Denver Zoning Code Text Amendment
Cherry Creek East Commercial Mixed Use Design Overlay District (DO-9)
Cherry Creek East Residential Design Overlay District (DO-10)

FINAL MARKUP - EFFECTIVE 2/13/2023

This document is the final markup of a text amendment to create two overlay zone districts for the Cherry Creek East neighborhood bounded by S. Steele Street, E. Cherry Creek North Drive, E. Alameda Avenue, S. Colorado Boulevard, and E. 1st Avenue. This text amendment establishes the Design Overlays (DO) and a map amendment to apply the overlays as follows:

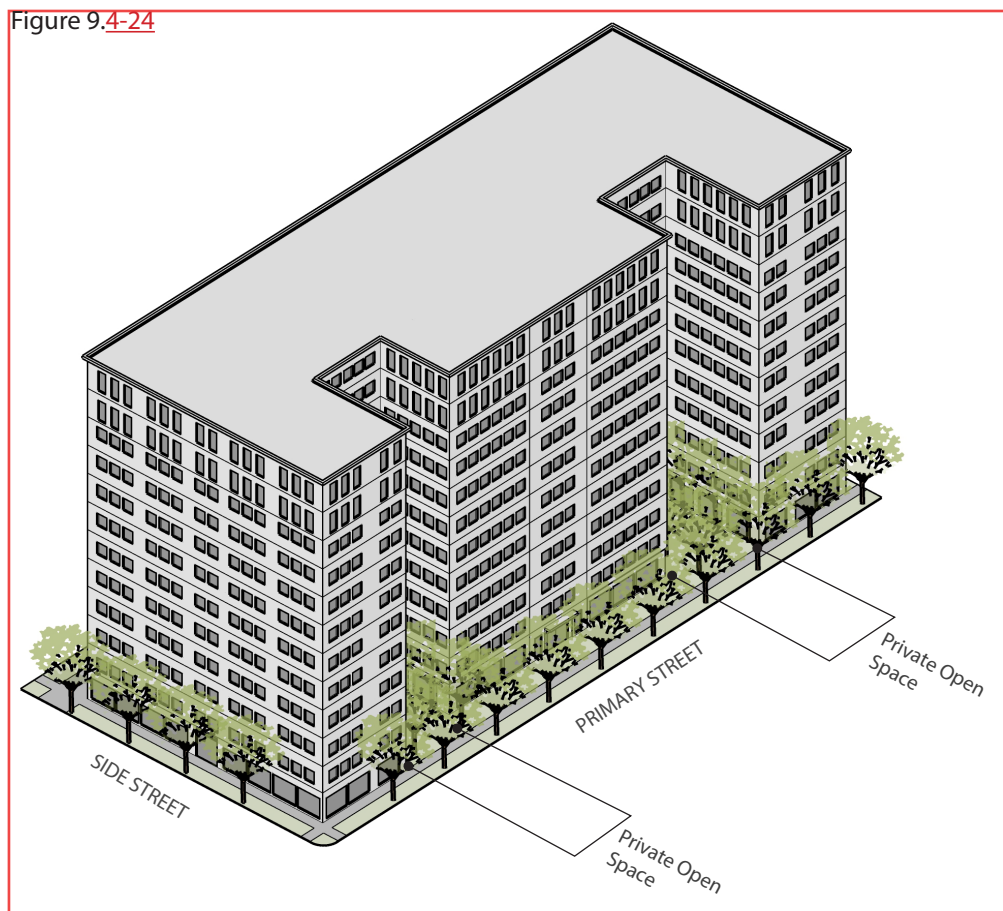
- i. Where a minimum 7 percent of the gross area of a Zone Lot is provided as Private Open Space meeting the rules of measurement set forth in Section 13.1.6.1.B, all Primary Structures on the Zone Lot shall not be required to meet the minimum Street Level Primary and Side Street Setbacks. See Figure 9.4-24.

Figure 9.4-25

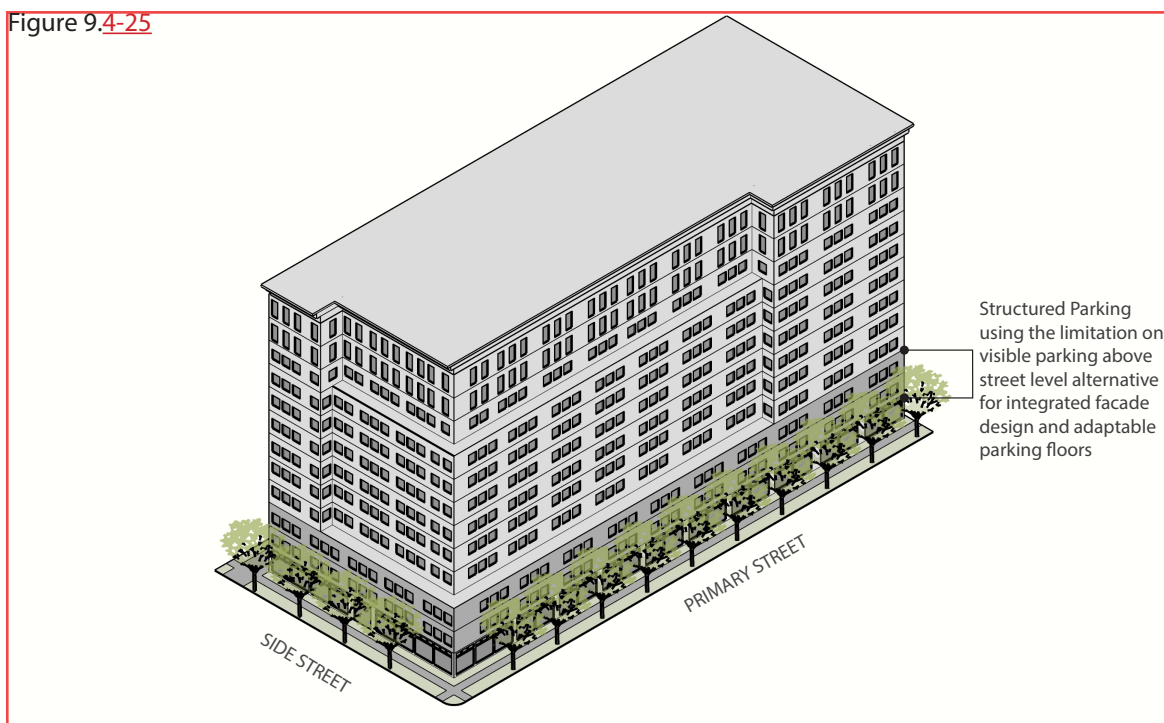
- a. **Intent**
To ensure structured parking designs that are compatible with the character and quality of the overall building facade and contain floors that are adaptable to non-parking Primary Uses where it is not possible to wrap or screen structured parking with other Uses.
- b. **Allowance**
Where 100% of a street-facing building facade containing structured parking meets all the standards set forth in paragraphs i-iv below, the resulting integrated facade

design and adaptable parking floors may be used as an alternative to the Limitation on Visible Parking Above Street Level in the DO-9 Overlay Zone district. See Figure 9.4-25.

- i. Where the alternative is used, street-facing facades containing structured parking shall be integrated into the overall facade design through use of:

- a) Similar building materials to those used on adjacent facade areas that do not contain structured parking; and
 - b) Facade articulation and fenestration patterns that integrate with portions of the building facade that do not contain structured parking.

- ii. Where the alternative is used, street-facing facades containing structured parking shall minimize the visibility of parking areas through use of:

- a) Non-transparent facade materials for a minimum height of 4 feet from the finished floor of each story; and
 - b) Fully-shielded LED or other lighting not exceeding 6,500 lumens behind a street-facing facade.

- iii. Where the alternative is used, street-facing facades containing structured parking shall be designed with parking floors that are adaptable to other uses for a minimum depth of 30 feet from the Primary or Side Street-facing building facade through use of:

- a) A minimum 12-foot floor-to-floor height, measured from the upper surface of the floor to the upper surface of the floor or roof next above; and
 - b) Floor plates that are level except to the minimum extent required for proper drainage; and

- c) Structures that are constructed to accommodate loads associated with office buildings per the International Building Code.
- iv. Where the alternative is used, Section 10.4.6.5 Parking Structure Design Standards shall apply in addition to the Standards set forth in this Section 9.4.5.13.F.4.

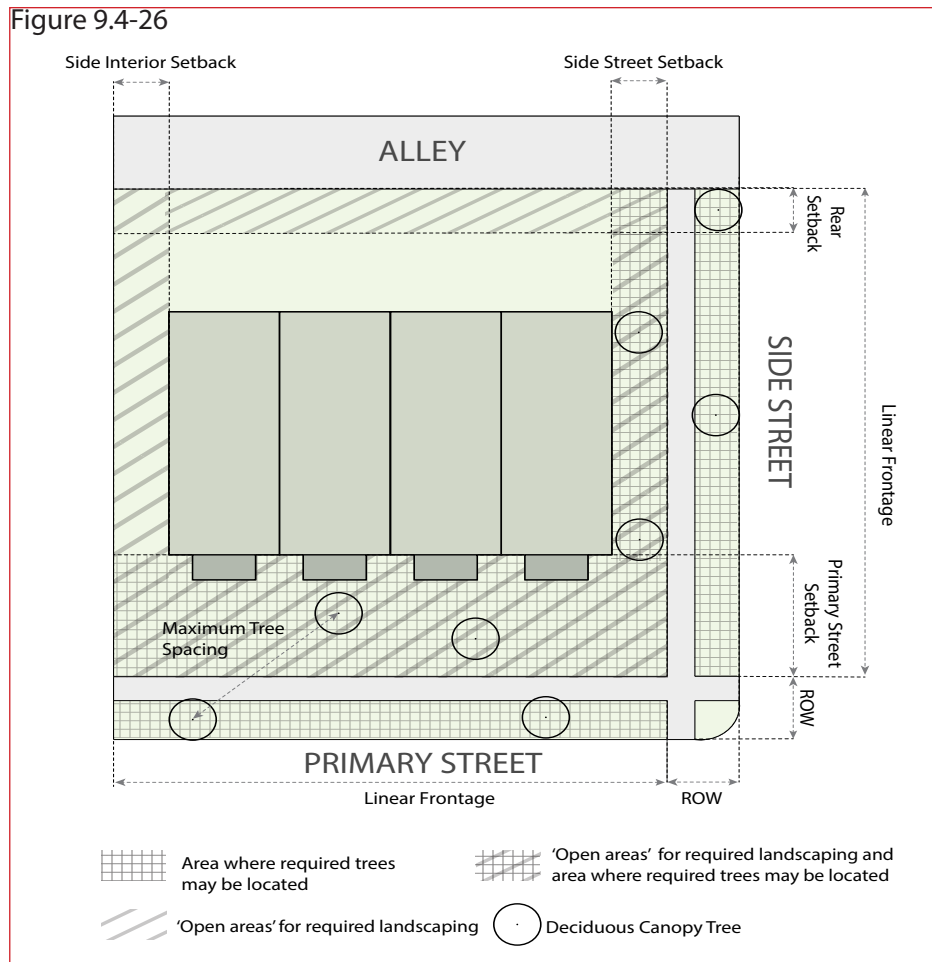
- i. A minimum of 60% of the applicable "open areas" shall be landscaped with live planting material and the remaining 40% shall be landscaped with either live or non-live landscaping material, according to Section 10.5.4.6 Landscaping Material Standards. See Figure 9.4-26.

- iii. On each Zone Lot, one deciduous canopy tree shall be planted for every 25 feet of linear frontage. Spacing of trees may vary, but the maximum spacing is 40 feet. See Figure 9.4-26.
